CONDITIONS FOR DONATION

Project: Washington Street Improvements Parcel 17A & 18

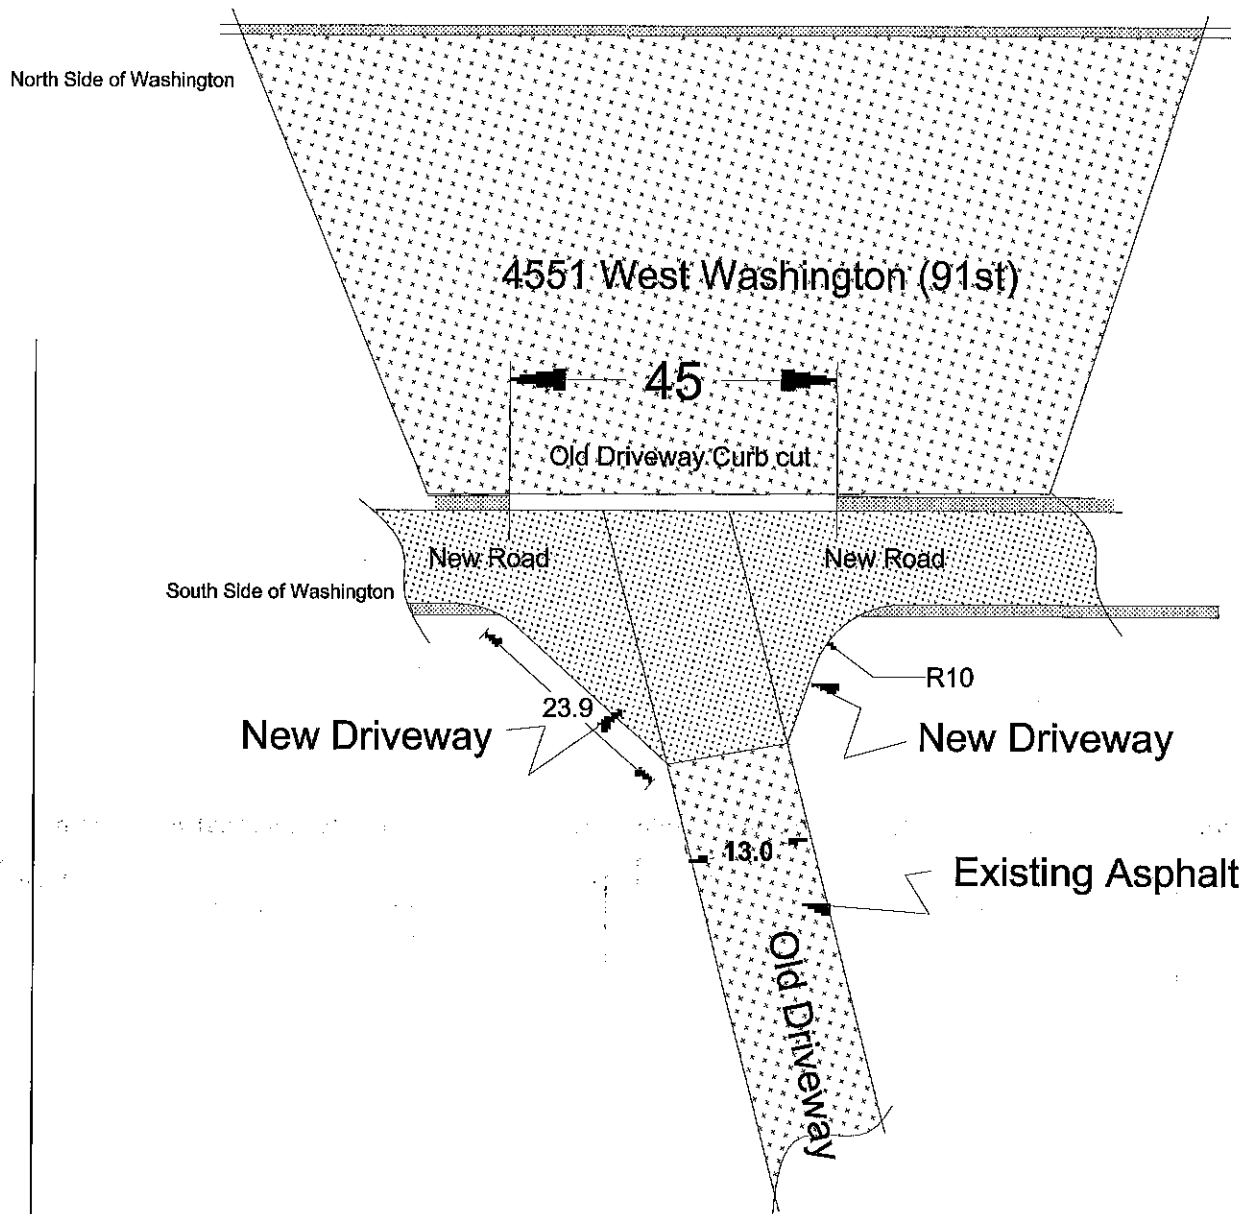
1. Replace fence with like or better: Current fence has two each 12-foot-wide double gate (24 foot opening), one west side (215+50), one east side (222+35) of drive way. The Gate support post are double 7-inch wood support post with cross brace for each gate hinge and at the end of each fence run for a total of eight double support ends (total 16 post). Replace with new or equivalent fence end supports. Install new or equivalent gates or reuse the existing gates.

2. Place a minimum of 4' chain link fence around the culvert trio (STR RCP2 214+00) and tie to the existing fencing for safety.
3. Place temporary fencing when existing fence is removed during construction.

4. Main Driveway entrance replacement: 50' curb cut as it is presently, driveway concrete thickness minimum 6 inch, 8" compacted gravel base under driveway with no mountable curb or curb bump to allow street runoff flows to pond. Must support loaded trash truck.

5. Replace the other two driveways, as they exist presently. The driveway in alignment with the pond will not have a hump in it.

4501 West Washington

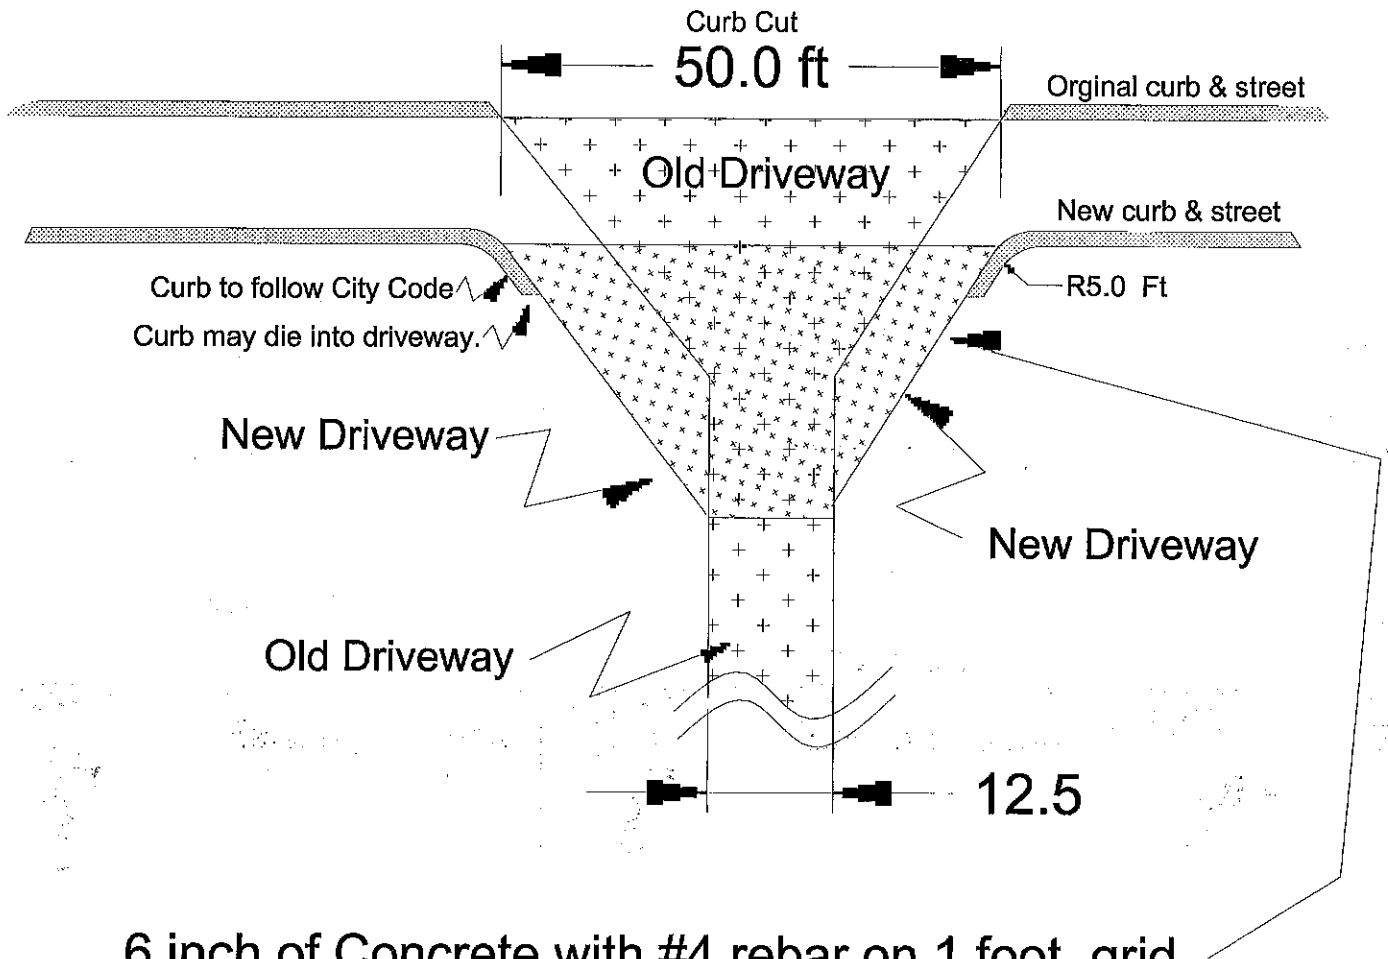
6 inch of Concrete with #4 rebar on 1 foot grid

Compact 8" gravel base

Must Support Loaded Trash Truck

No Curb bump since any street runoff flows to pond
